**Rockwall ISD – Updated Site Plans for Ninth Grade Center Projects:
SP 2022-17 (FM1141& Quail Run) & SP2022-18 (John King Blvd at GBCCA)**

TO: Planning and Zoning Commission
FROM: Bethany Ross; *Planner*
DATE: August 30, 2022
SUBJECT: MIS2022-018; *Exceptions Related to a Public Secondary School at 2852 FM-1141*

CASE CAPTION: Discuss and consider a request by Robert Howman of Glenn Engineering Corp. on behalf of William Salee of the Rockwall Independent School District (RISD) for the approval of a Miscellaneous Case for Exceptions associated with a Public Secondary School on a 76.068-acre tract of land identified as Tracts 14-01 & 14-11 of the J. M. Glass Survey, Abstract No. 88, City of Rockwall, Rockwall County, Texas, zoned Planned Development District 94 (PD-94) for limited Neighborhood Services (NS) District land uses, addressed as 2852 FM-1141, and take any action necessary.

EQUIPMENT LAYOUT

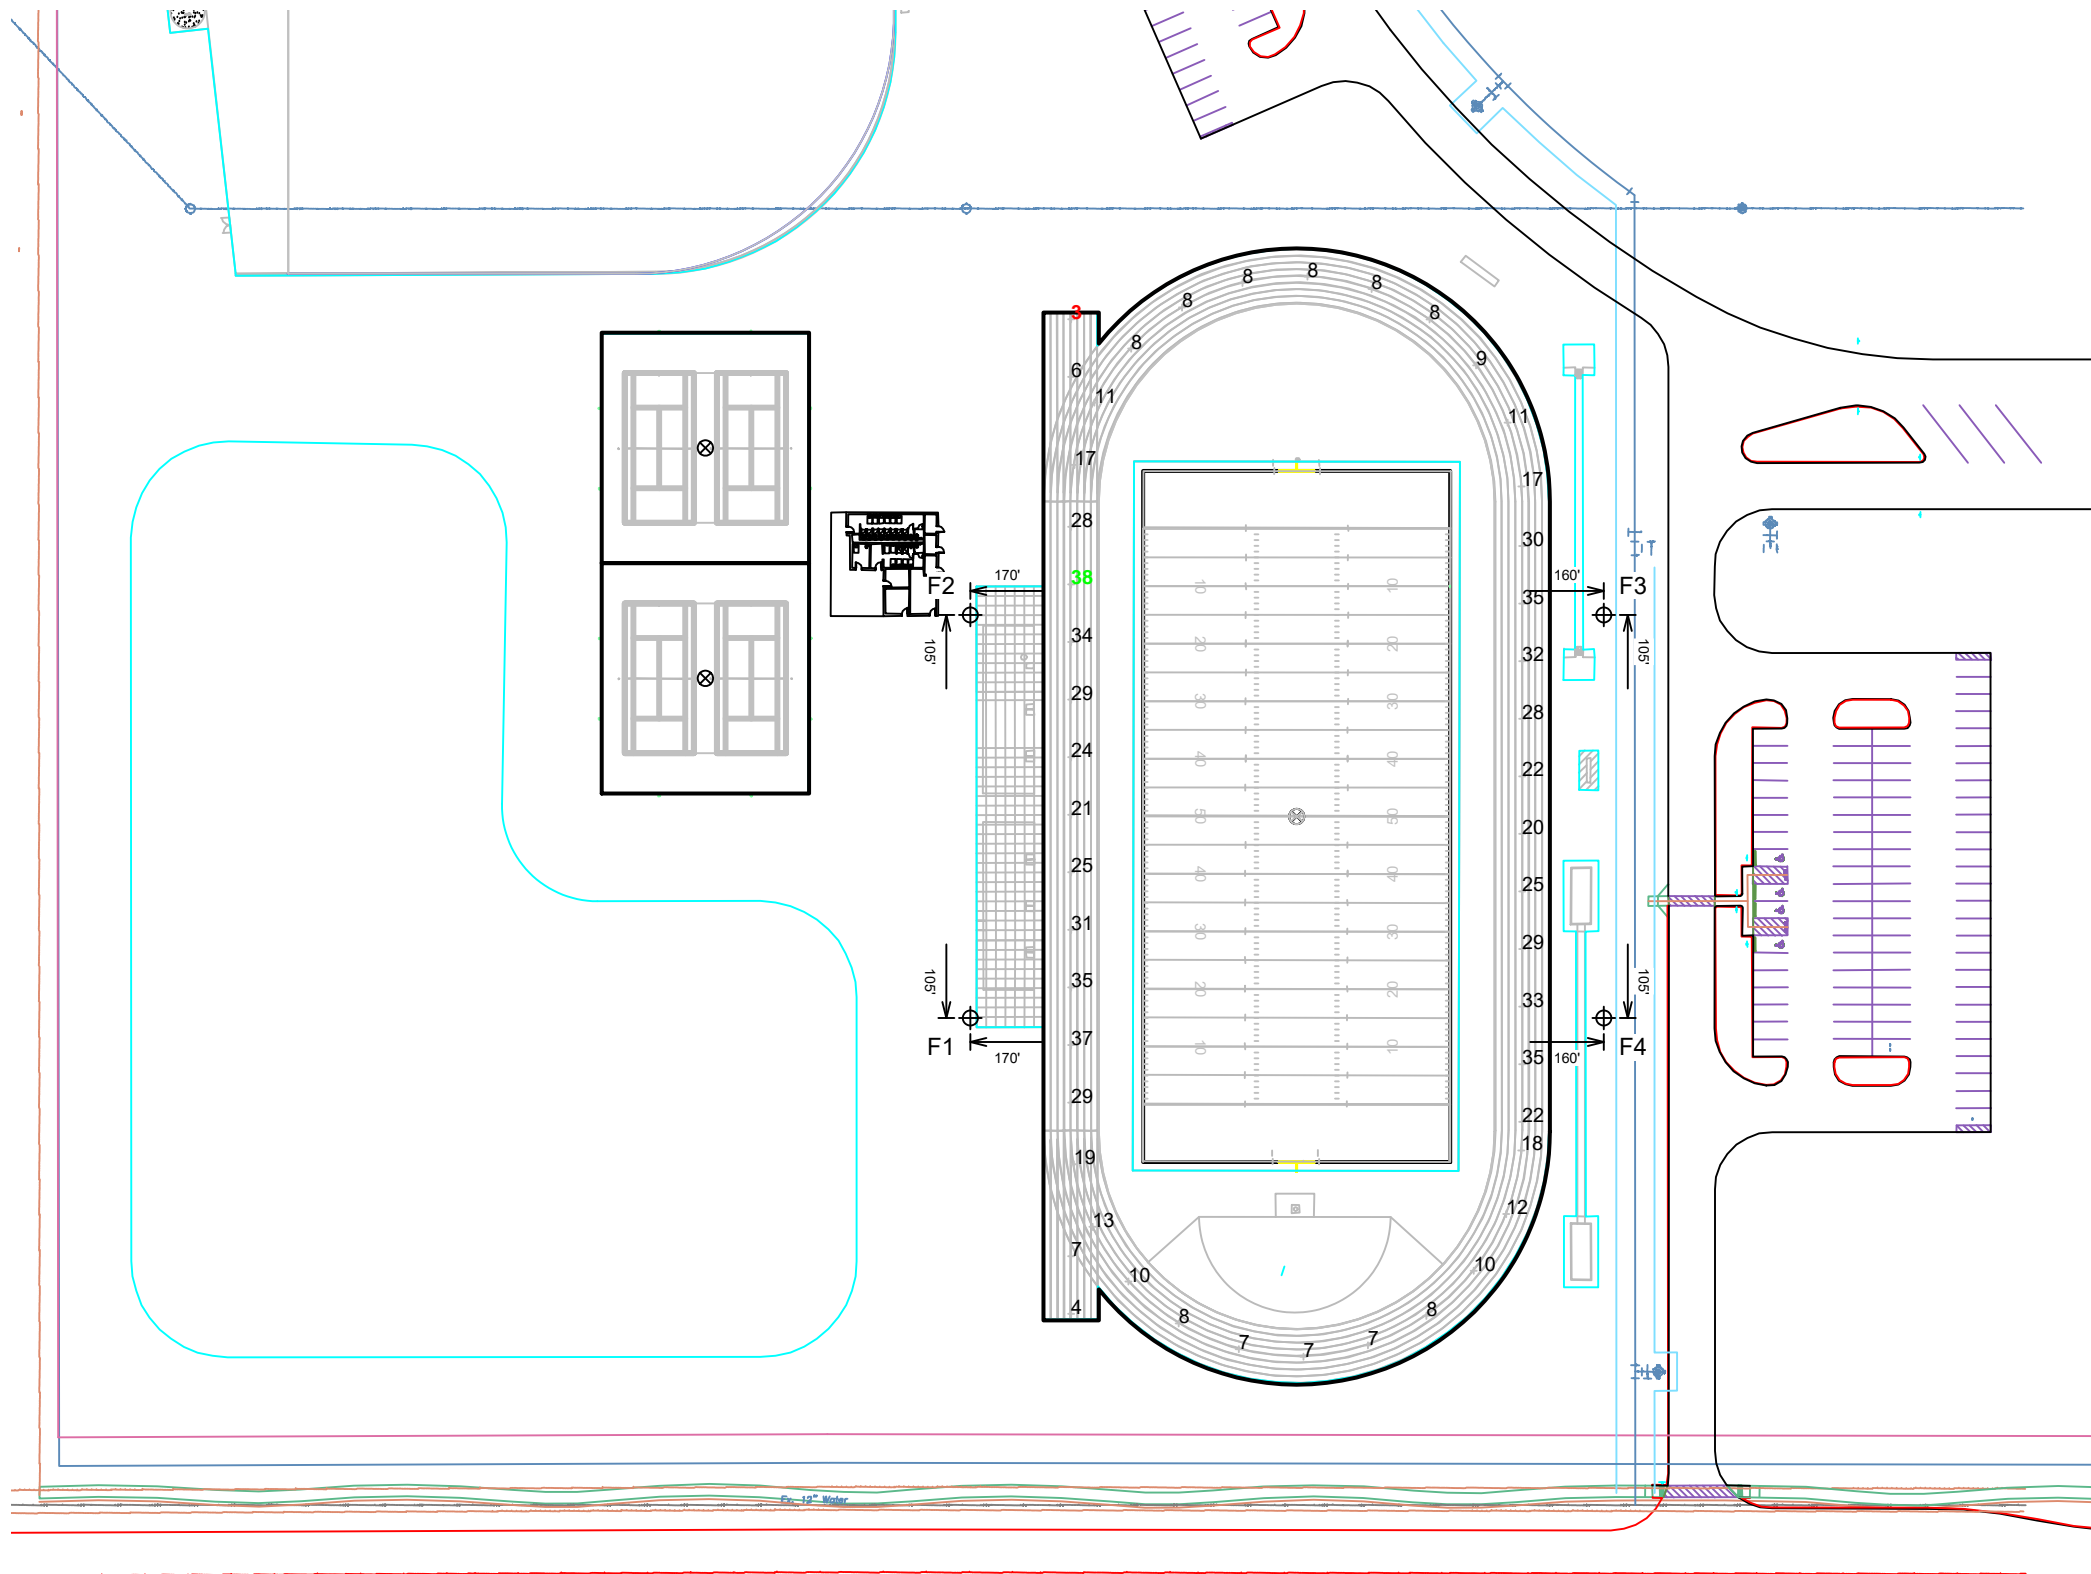
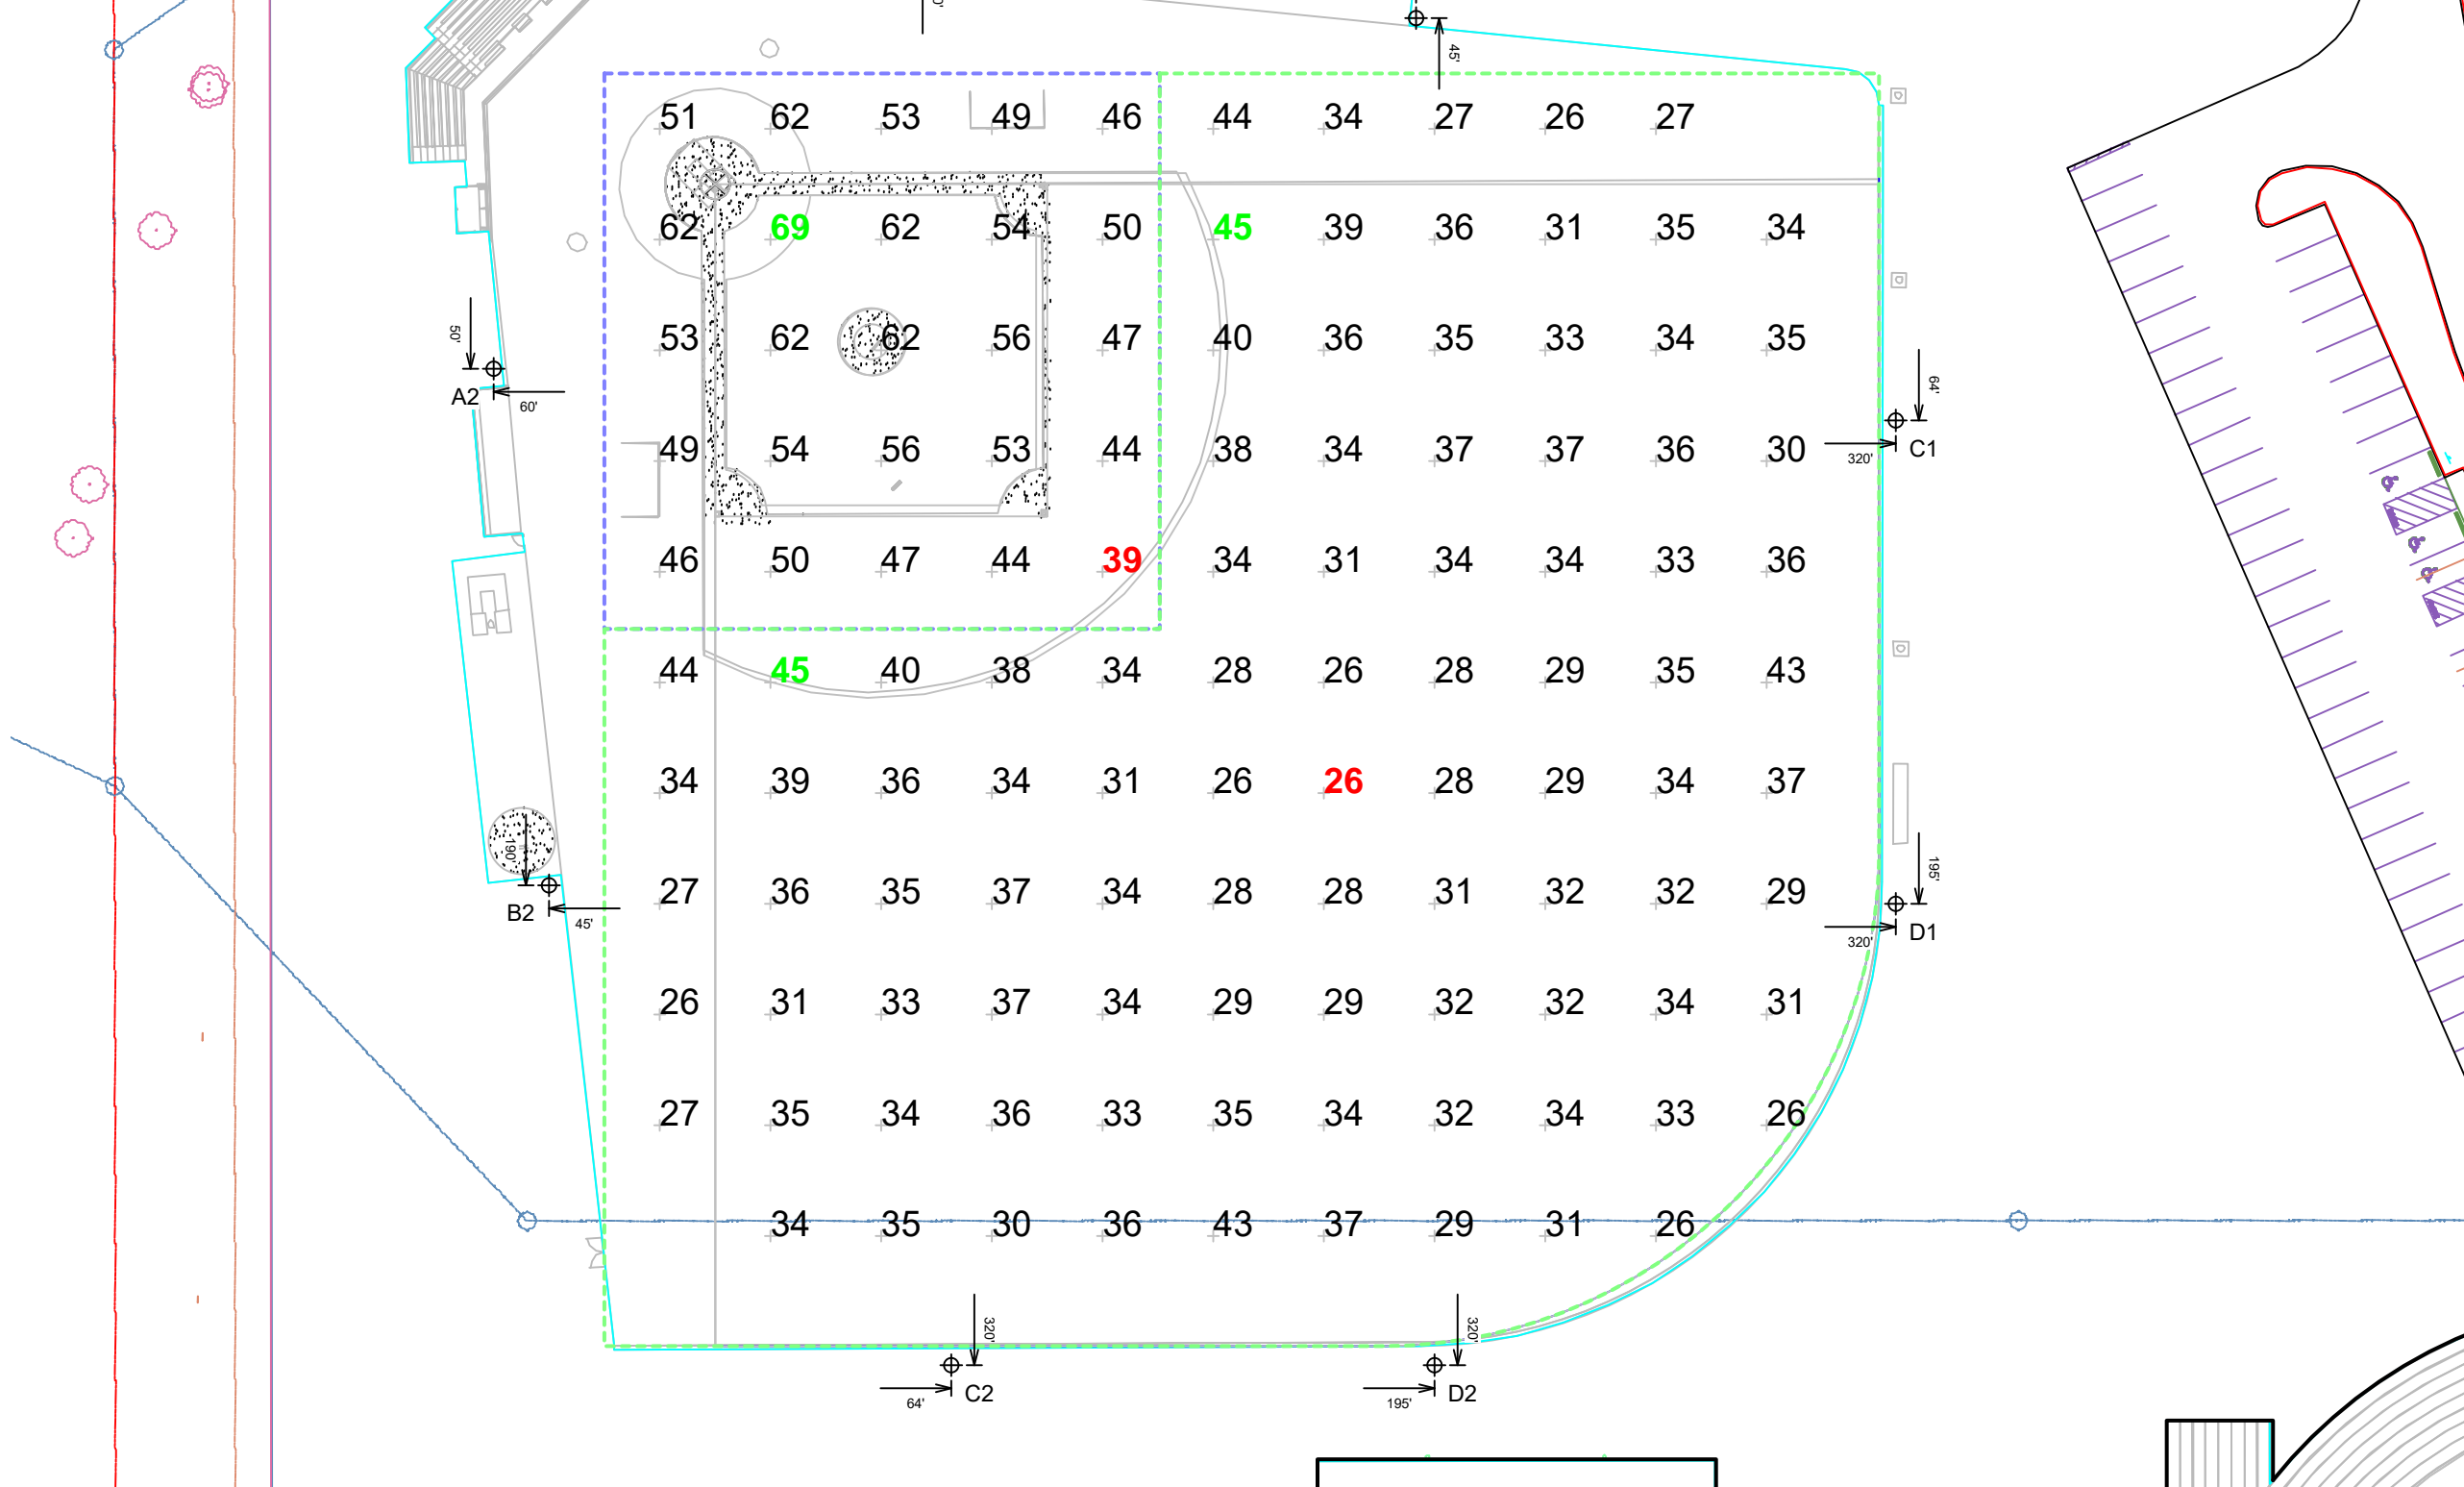
According to Subsection 03:03(G), *Illumination*, of Article 07, *Environmental Performance*, of the Unified Development Code (UDC), "(t)he maximum outdoor maintained, computed and measured illumination level within any non-residential development shall not exceed 20 FC outdoors at any point on the site..." The applicant is requesting an exception to the maximum allowed foot candles within the sports fields proposed on the site. The maximum proposed illumination level represented in the provided photometric plan is 70 FC or 50 FC greater than what is permitted by the UDC. Due to the proposed location of the sports fields on the subject property, staff has requested that the applicant provide an overall photometric plan to determine the foot-candle measurements at the property lines. If the proposed photometric plan exceeds the allowable 0.2 foot-candles at the property line, the applicant will be required to request an additional exception.

According to Section 03:03(D), *Height*, of Article 07, *Environmental Performance*, of the Unified Development Code (UDC), "(n)o light pole, base or combination thereof shall exceed 30 feet..." The applicant is requesting an exception to the maximum light pole height within the sports fields proposed on the site. The maximum proposed light pole height represented in the provided photometric plan is 80 feet.

M.7 Please provide an overall photometric plan for the site. If the foot-candles located at the property line of either property exceed the allowable 0.2 foot-candles at the property line, another variance will need to be requested.

Per the above referenced comment, Rockwall ISD is requesting the following exceptions to install sports field lighting as necessary for utilization by the campus when daylight levels are not adequate for practice and game events:

Rockwall ISD requests acceptance of the requested light pole height exceptions as proposed to ensure adequate playability of and safety of the field use.
